Notice of Intent

Type of Action: APD Change

Procedure Description: COG Operating requests permission to perform a Bradenhead Cement Job previously approved by BLM as detailed on the attached procedure for Gin and Tectonic Federal Com 701H, 702H, and 703H.

GIN AND TECTONIC FEDERAL COM 701H, US Well Number: 3002548434, Case Number: NMNM120906, Lease Number: NMNM120906,
Operator:COG OPERATING LLC

Figure 1: Offline Cement Tool Schematics

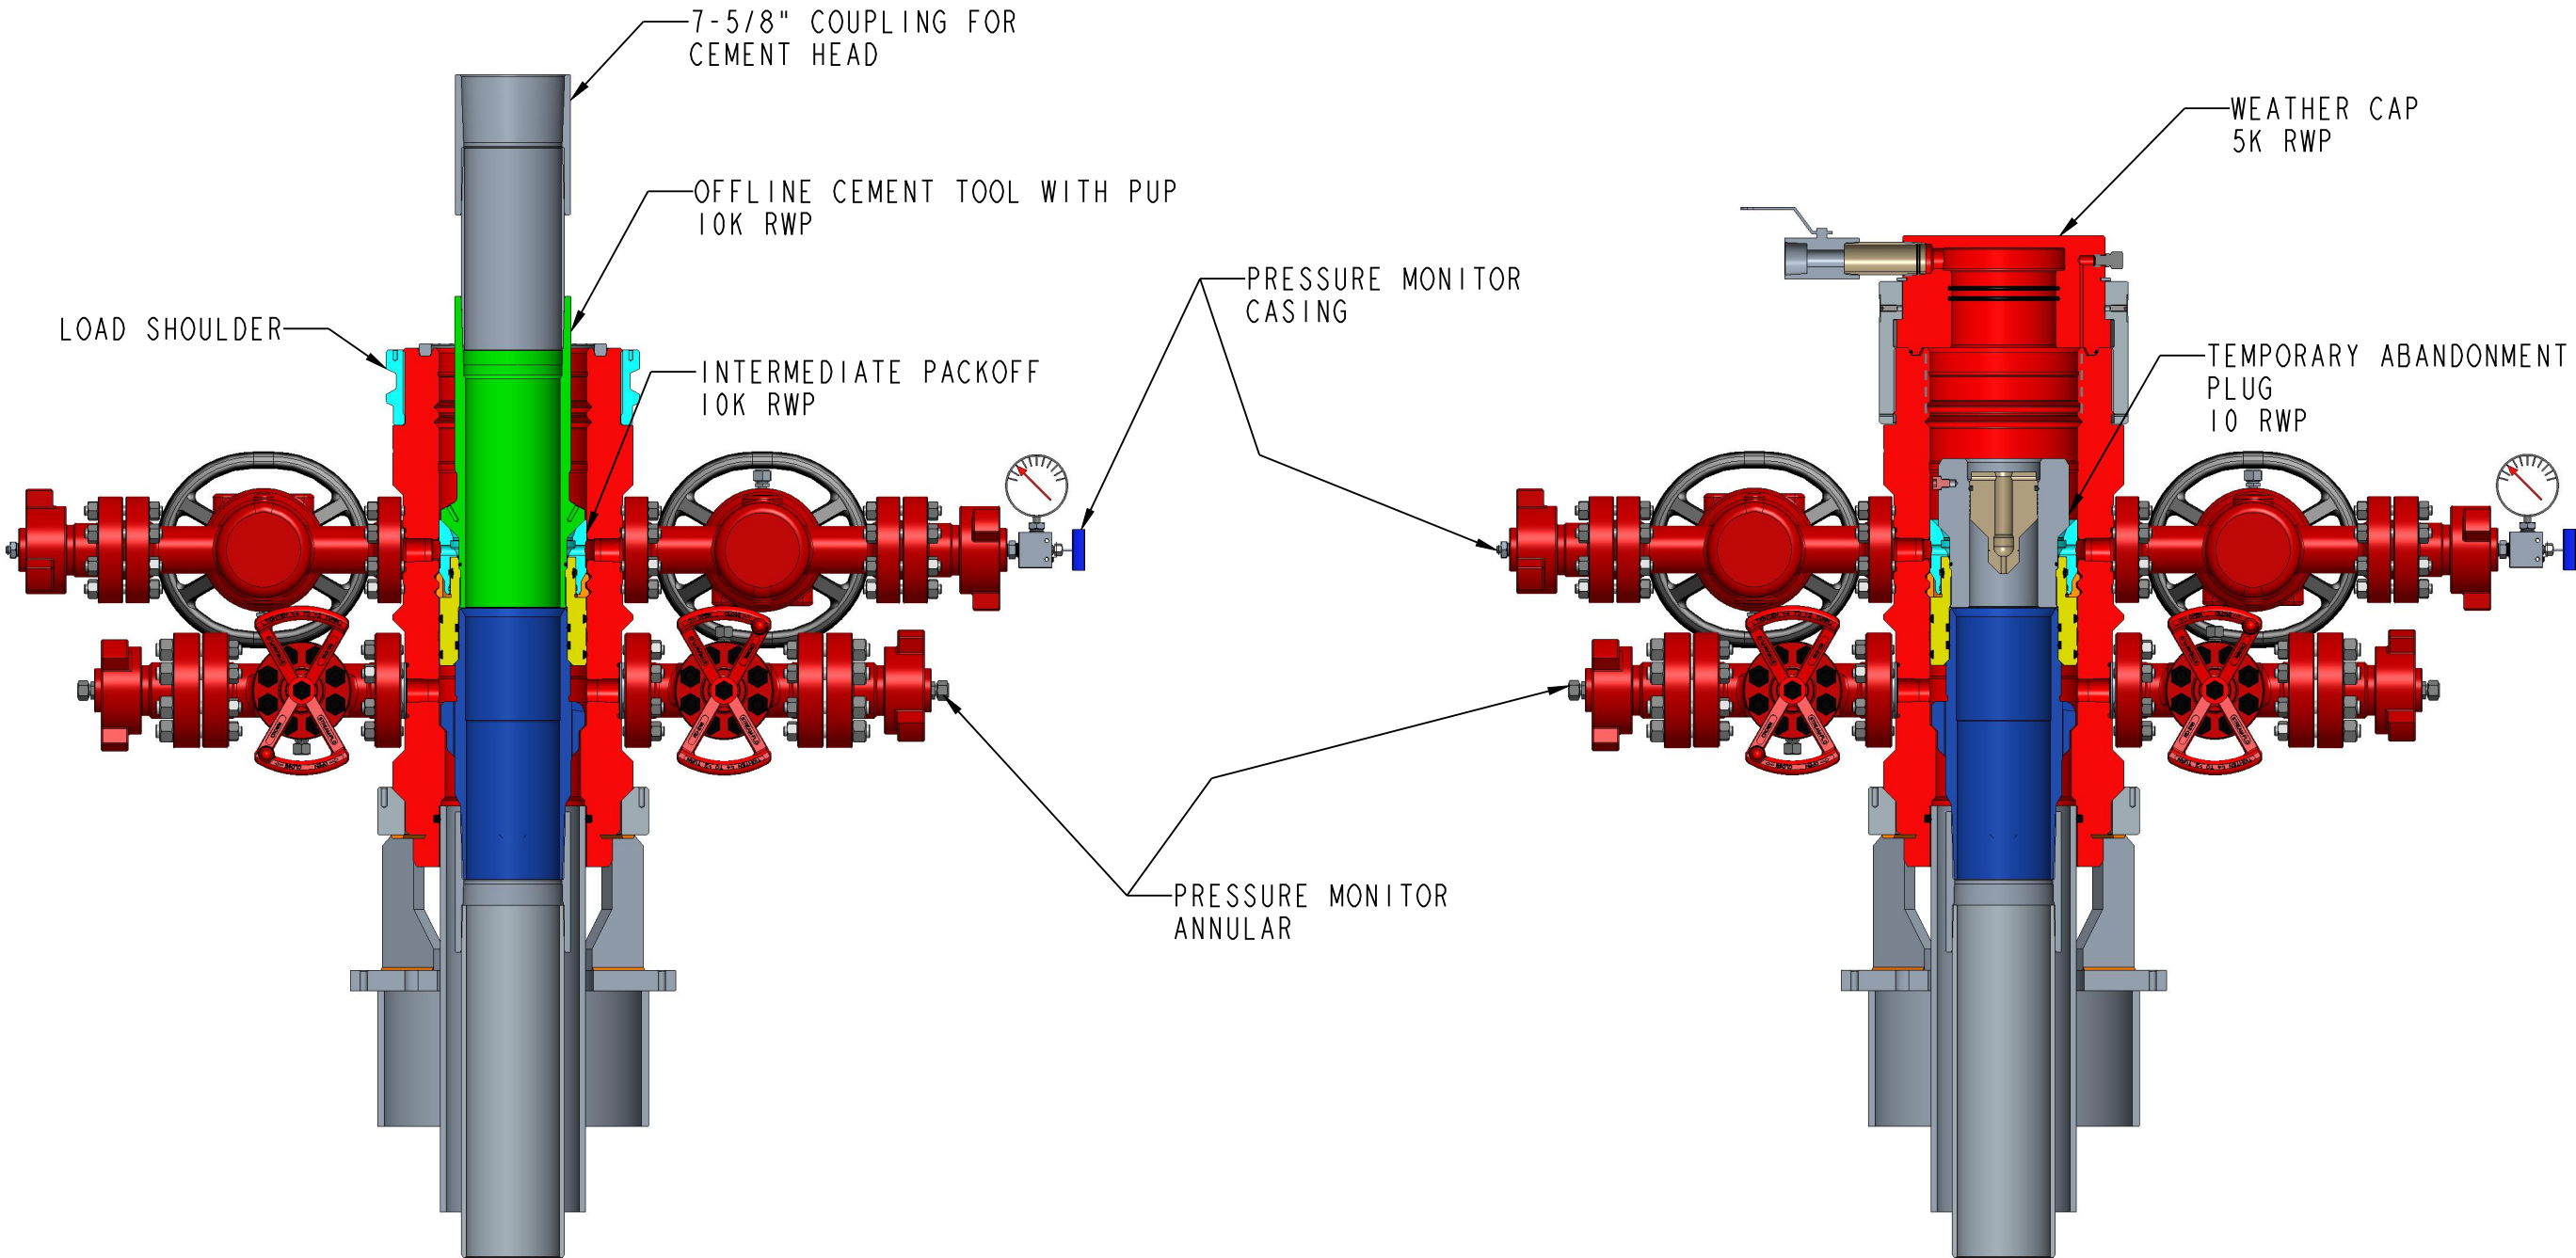
11. Install offline cement tool.
 - a. Current offline cement tool schematics can be seen in Figure 1 (Streamflo)
12. Rig up cement head and cementing lines.

Figure 2: Back Yard Rig Up

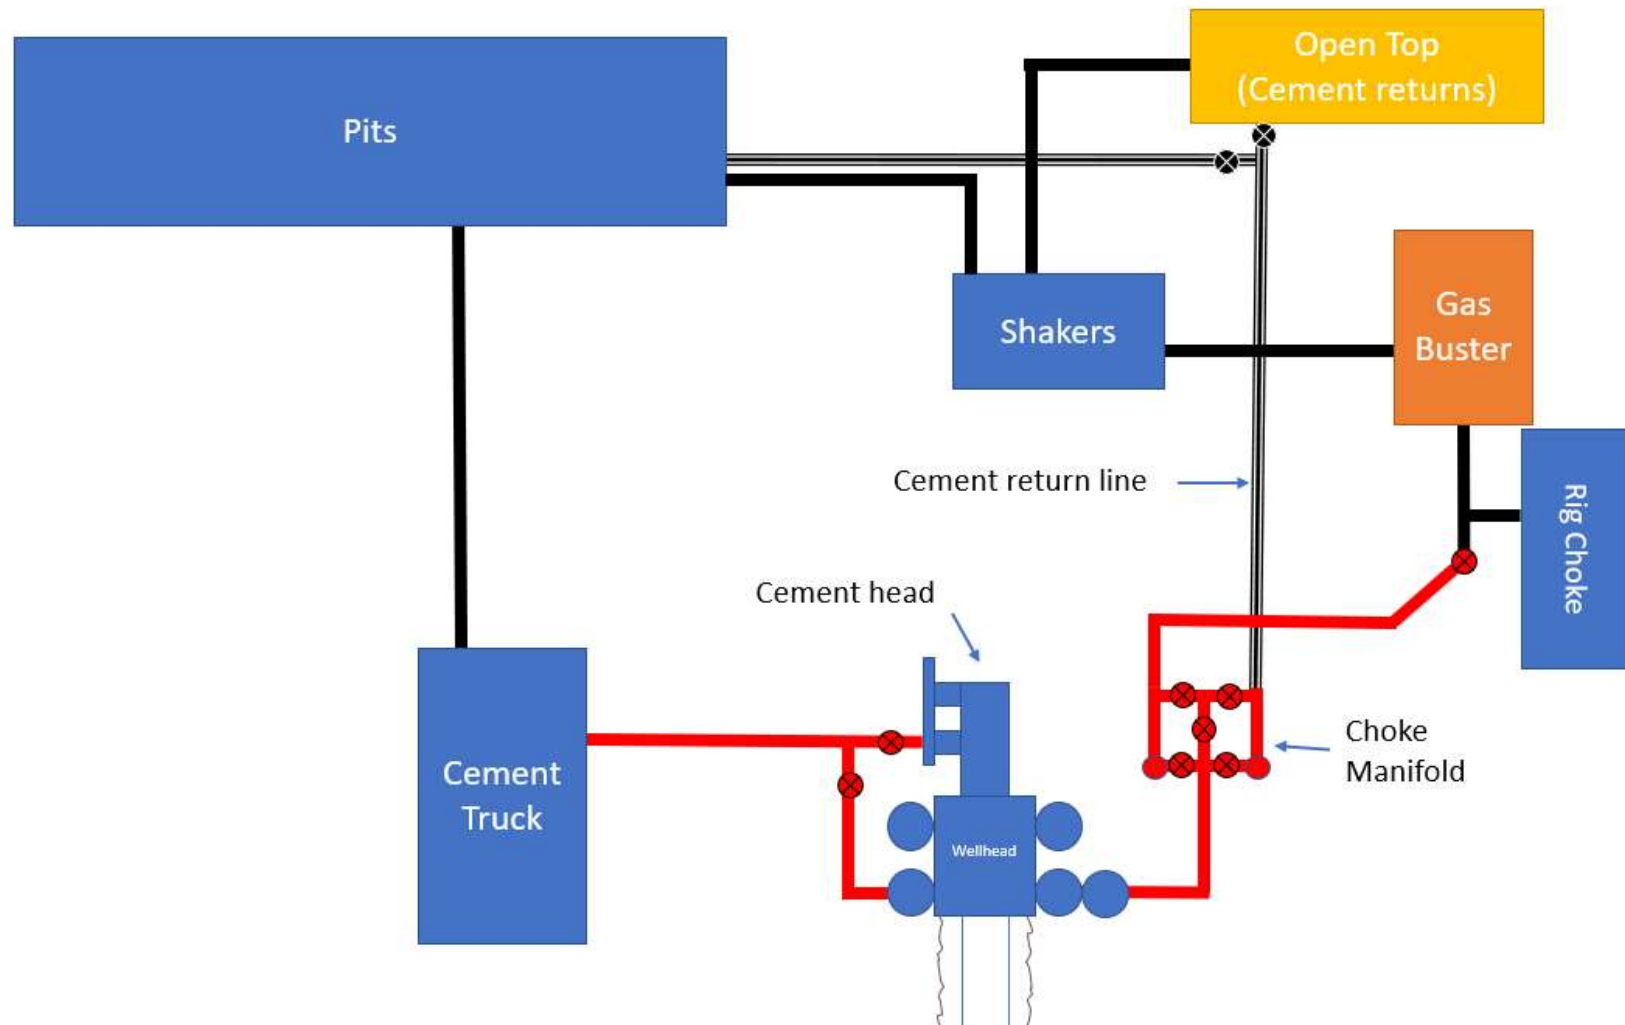
- b. If either test fails, perform corrections and retest before proceeding.
 - c. Return line schematics can be seen in Figure 2.
10. Remove TA Plug/BPV from the casing.
